**Addendum No. 1**

**Subject:** General Louis Wagner Middle School Culinary Art Suite Renovation  
SDP Contract Nos. B-022C, B-023C, B-024C, B-025C

**Location:** General Louis Wagner Middle School  
1701 W Chelton Ave  
Philadelphia, Pennsylvania 19139

**This Addendum, dated 1 of April, 2021, shall modify and become part of the Contract Documents for the work of this project. Any items not mentioned herein, or affected by, shall be performed strictly in accordance with the original documents.**

DRAWING NO.  
**E - 300**  
SHEET 18 OF 23

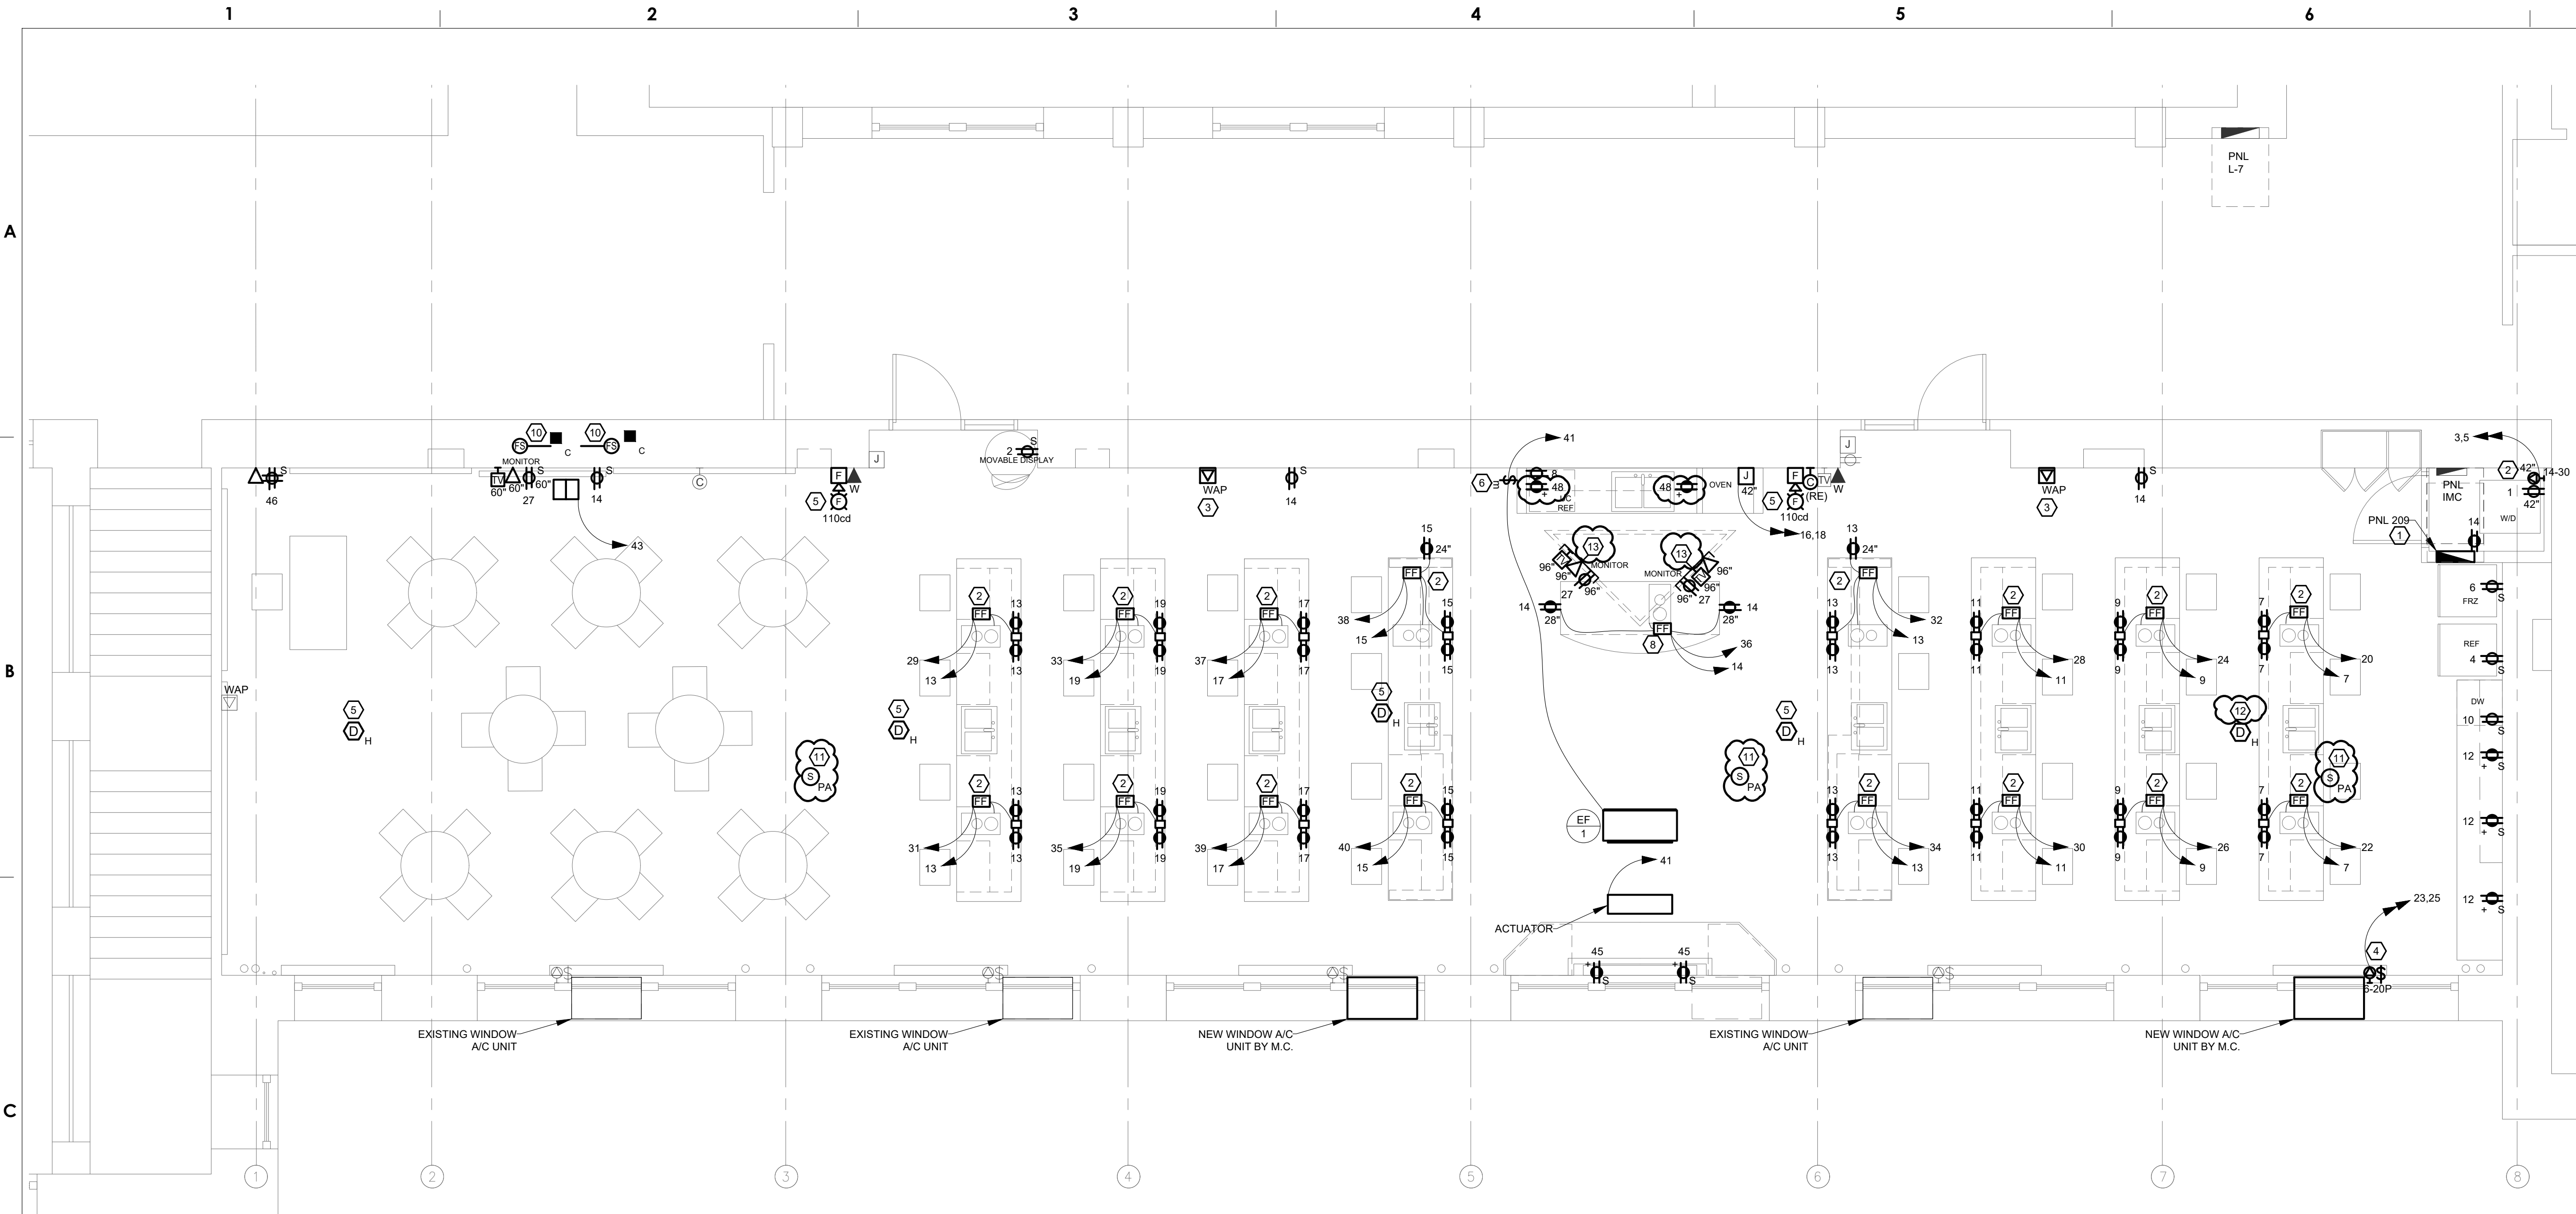
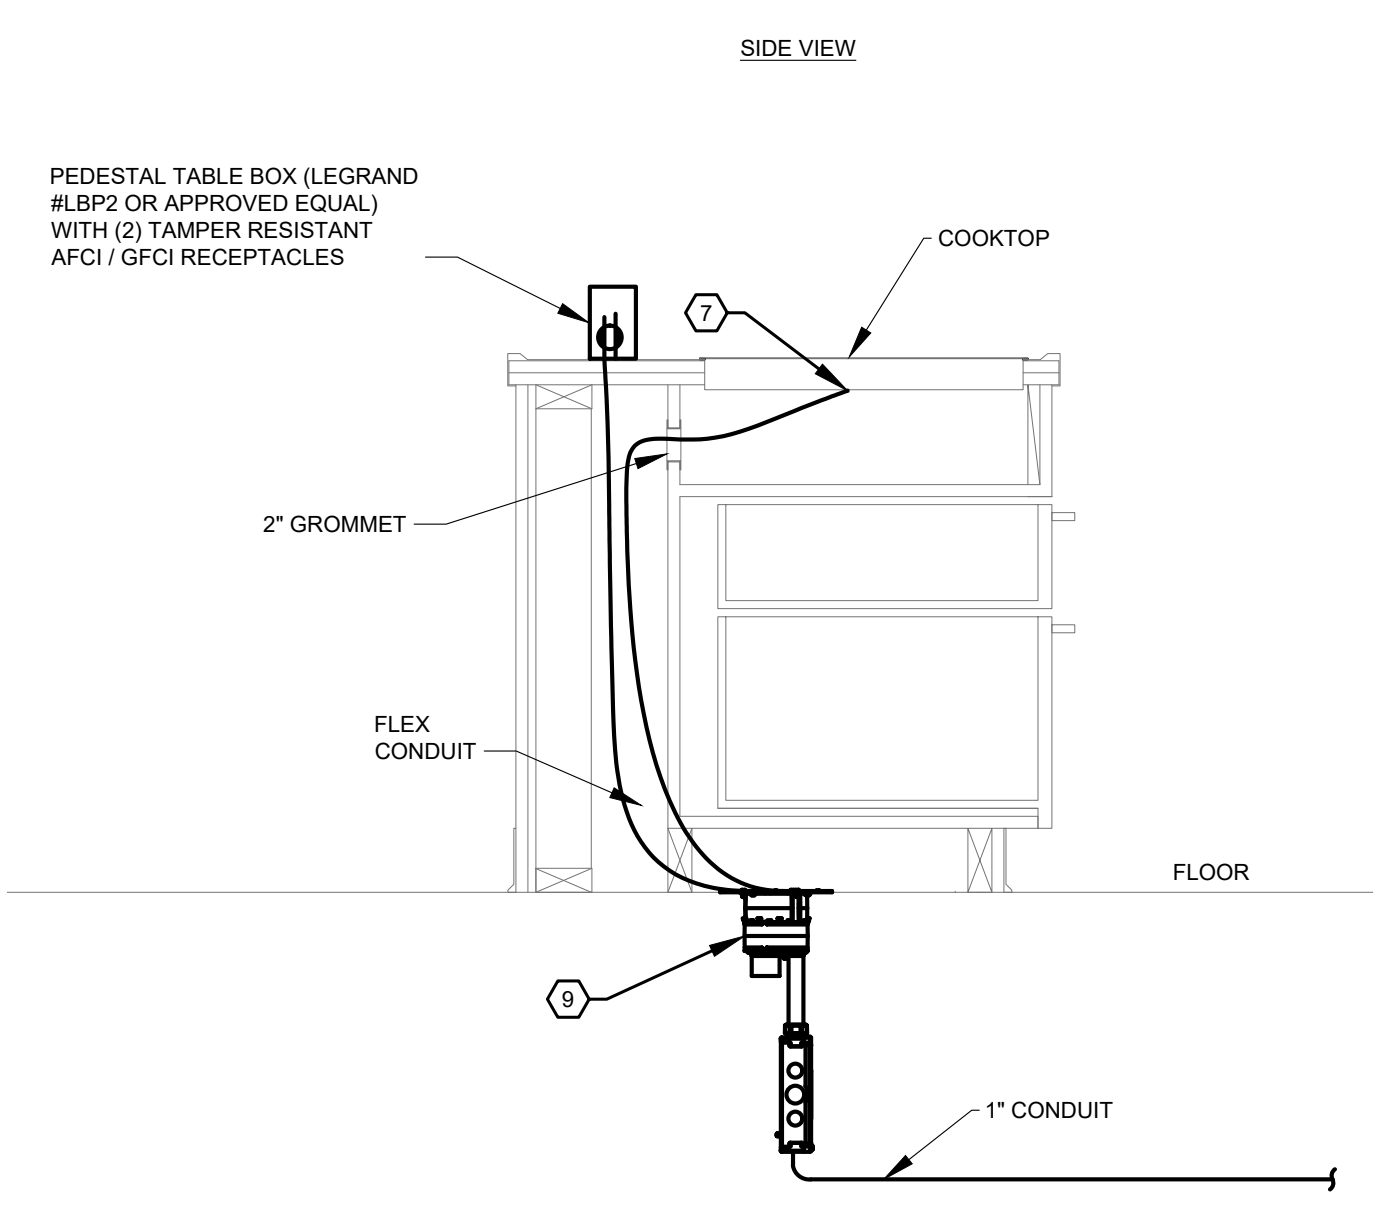
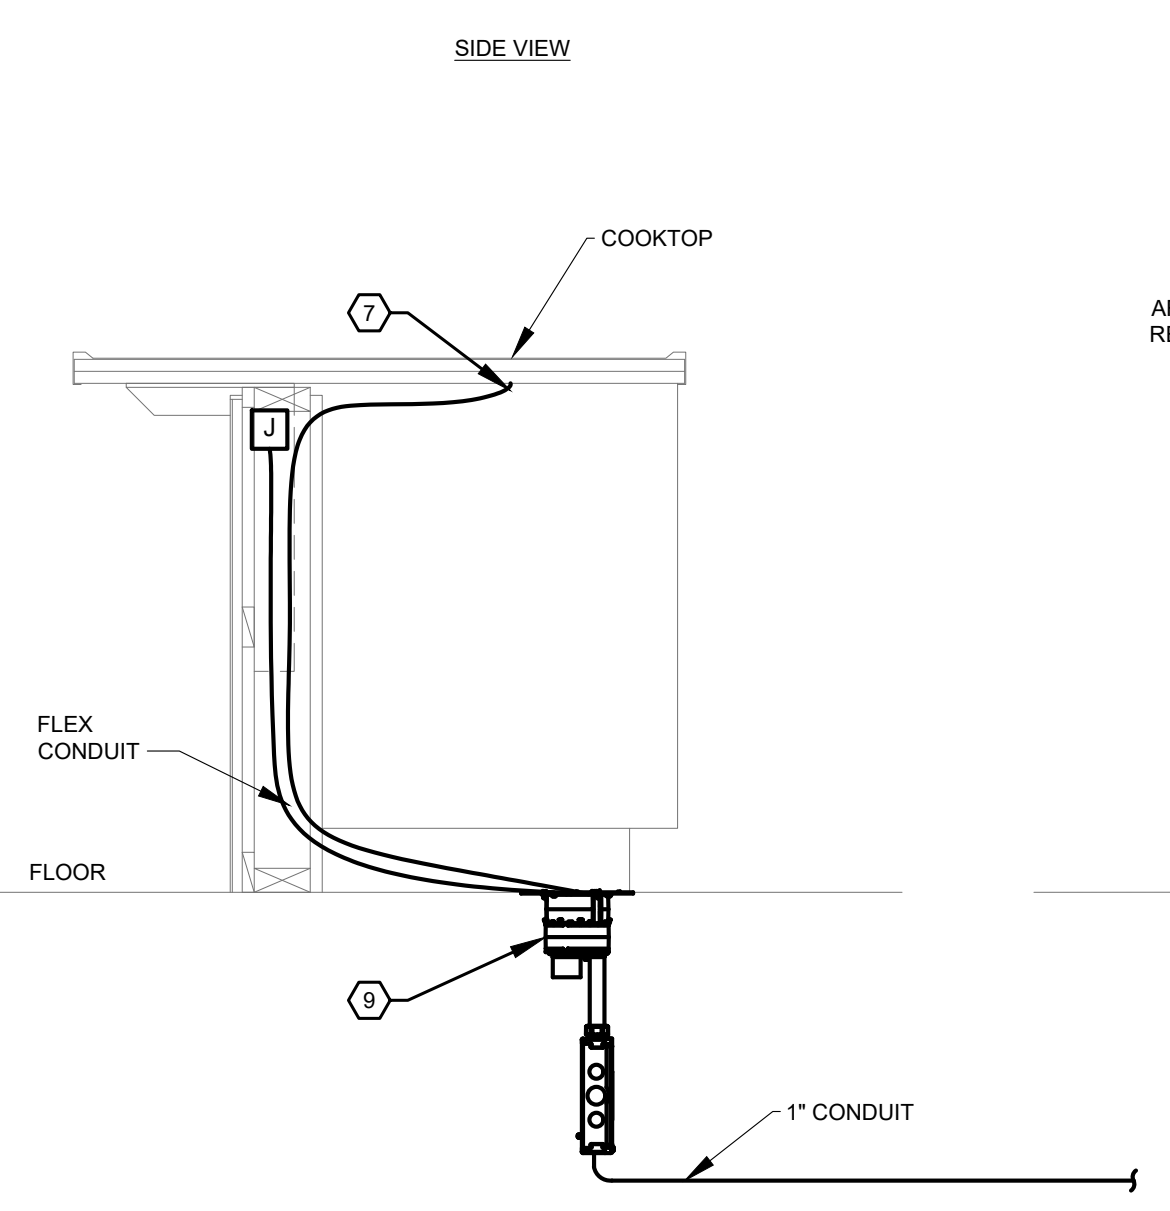
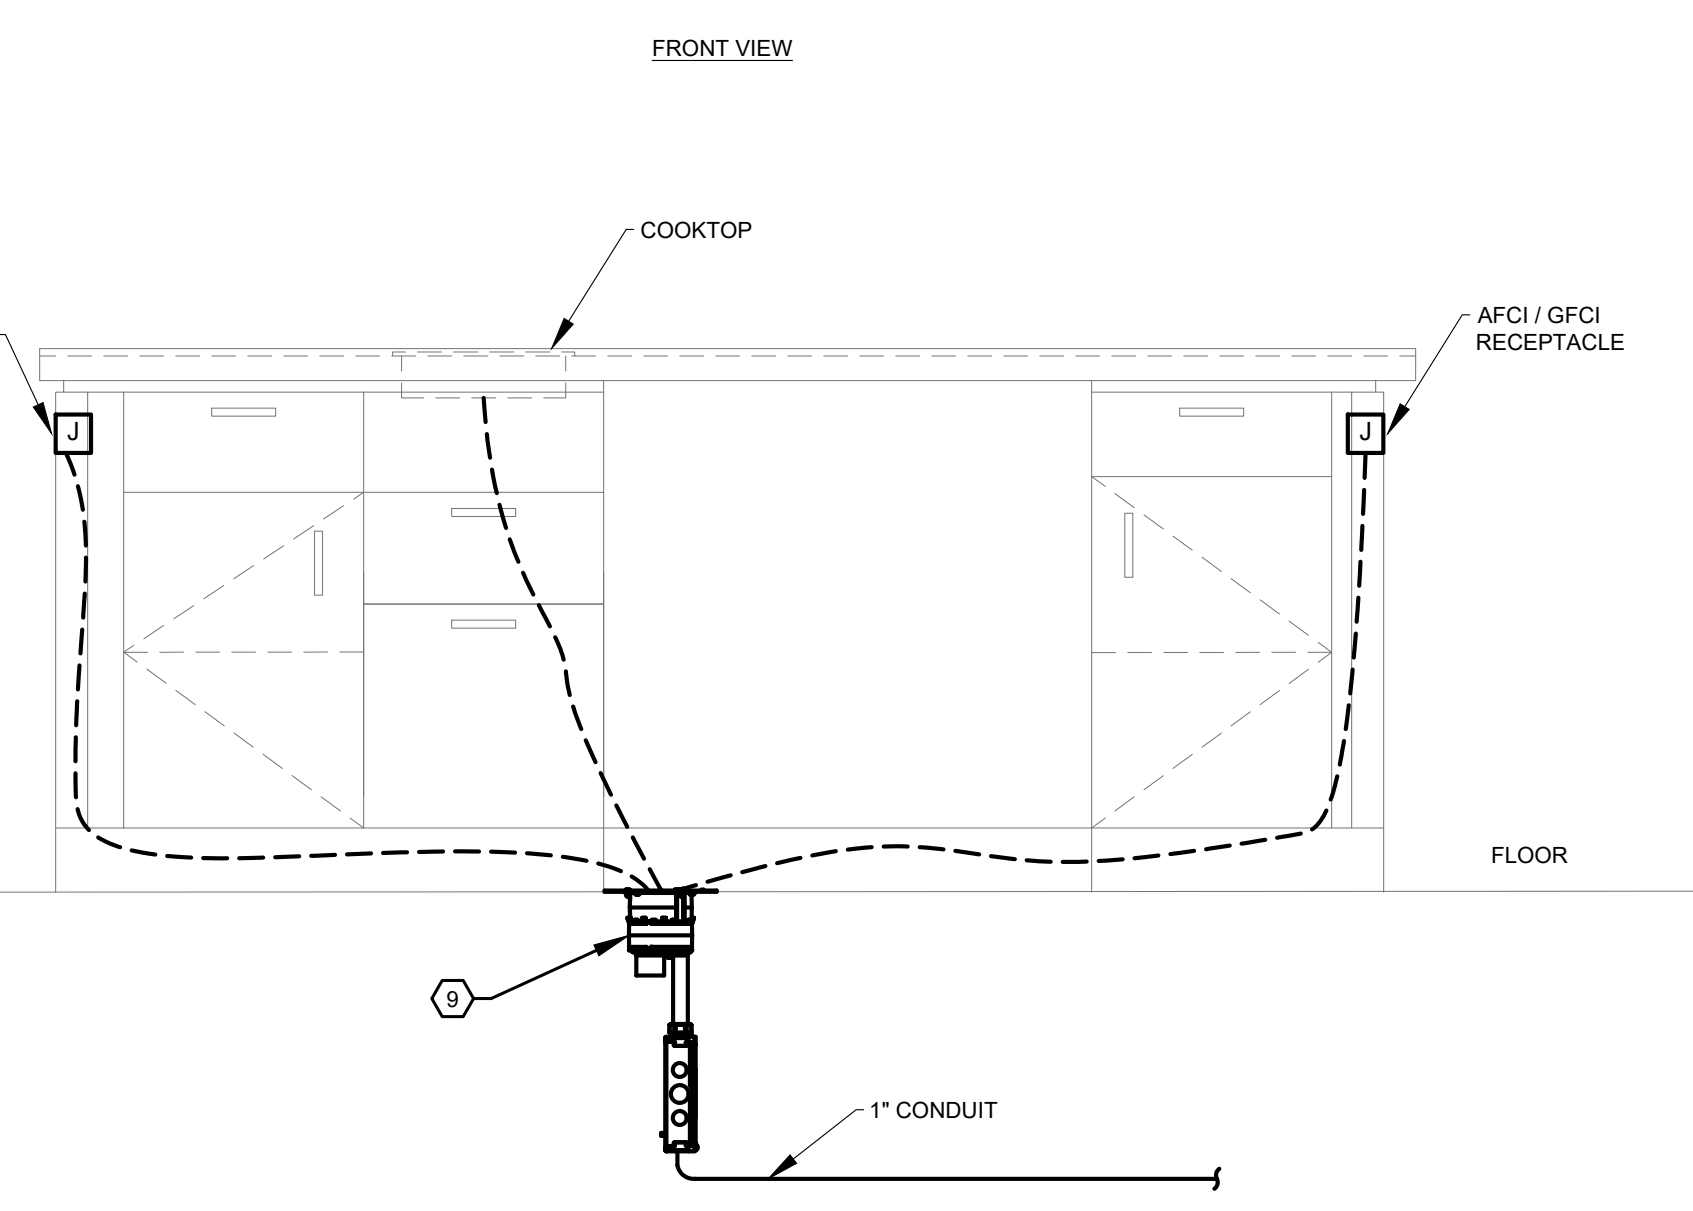
#### **Drawing: E-300 Room 209 and 210 Power and Special Systems New Plans**

- a. Added two duplex gfci receptacle above counter at instructor's demonstration area.
- b. Added existing to remain ceiling mounted PA speaker, see new sheet note #11.
- c. Added sheet notes #12 & #13.
- d. **\*ADD NOTE:** "EC to provide and install (1) quad outlet inside base cabinet at demonstration station for new A/V rack. Connect to spare circuit breaker in new panel 209. Provide recessed poke thru device (see sheet note 9) to be installed at demonstration station for power and data connections. Provide a data outlet with 1" conduit down to floor below for A/V wiring connections to A/V rack at demonstration table."

Question 2: Regarding general note 11 on E-300, please confirm painting of raceways is by the GC, per spec section 011000-1.2(1)(j).

**Answer 2: GC to paint all new and existing piping, conduit, raceway, etc. to match adjacent wall / surface.**
